# City Commission Review Petition DB-18-17 SUB

Design Plat Review for Oaks Preserve Cluster Residential Subdivision, to create 295 single-family residential lots on 95.17 acres. Located West of SW 50<sup>th</sup> Terrace, between SW Archer Road and SW 57<sup>th</sup> Avenue.

DRB Review  
Recommendation to City Commission

## Cluster Subdivision Design Plat City Commission Review and Approval

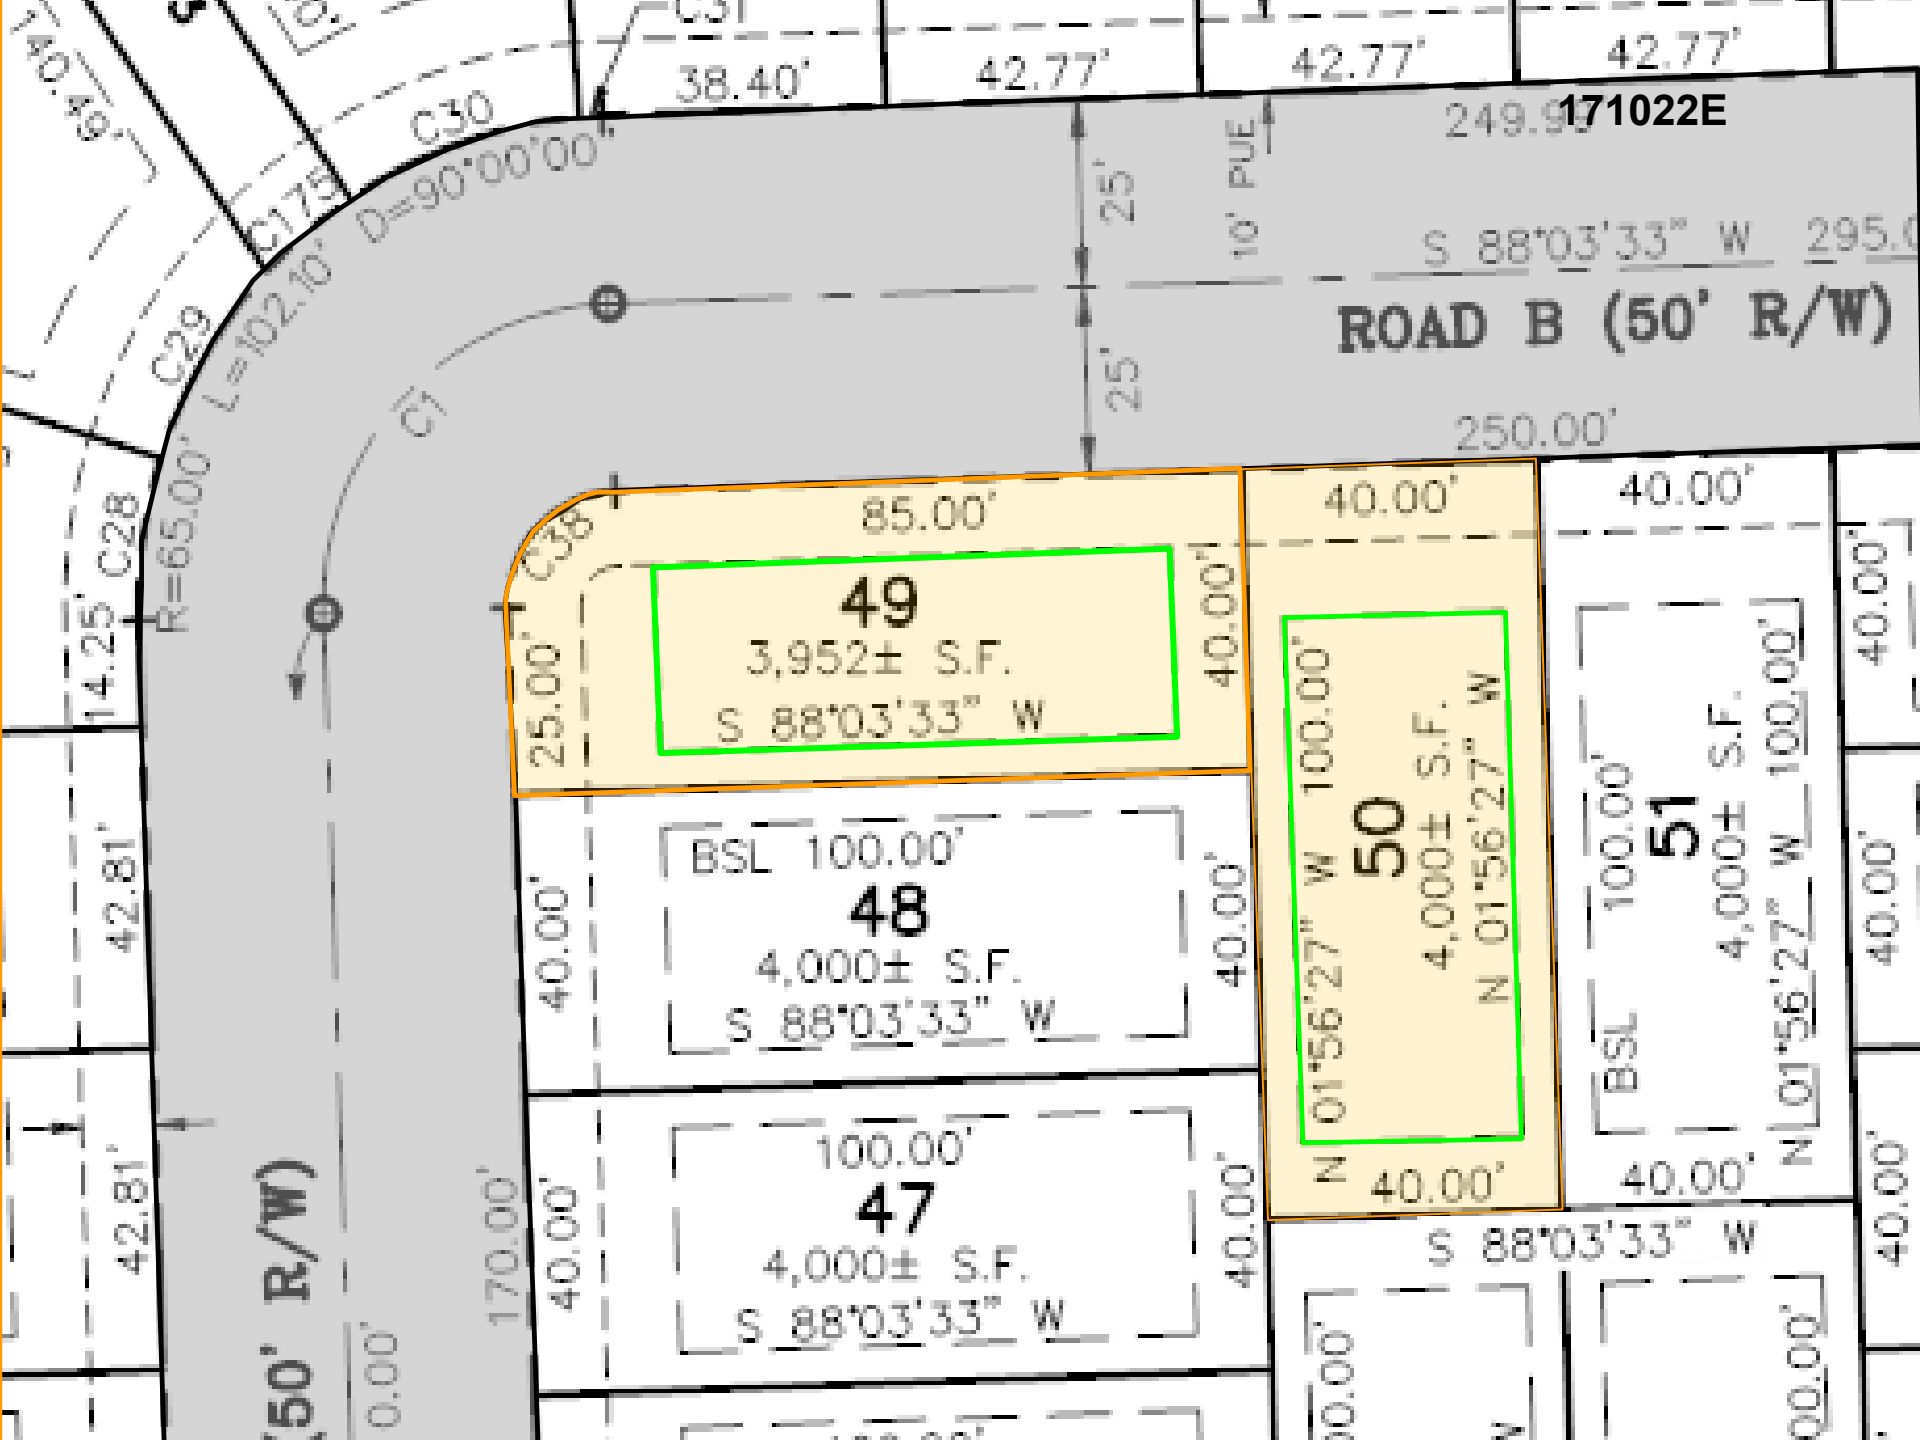
*The common area between lots 135 and 136 shall be redesigned to better accommodate future connection to external developments and/or planned regional roadways.*
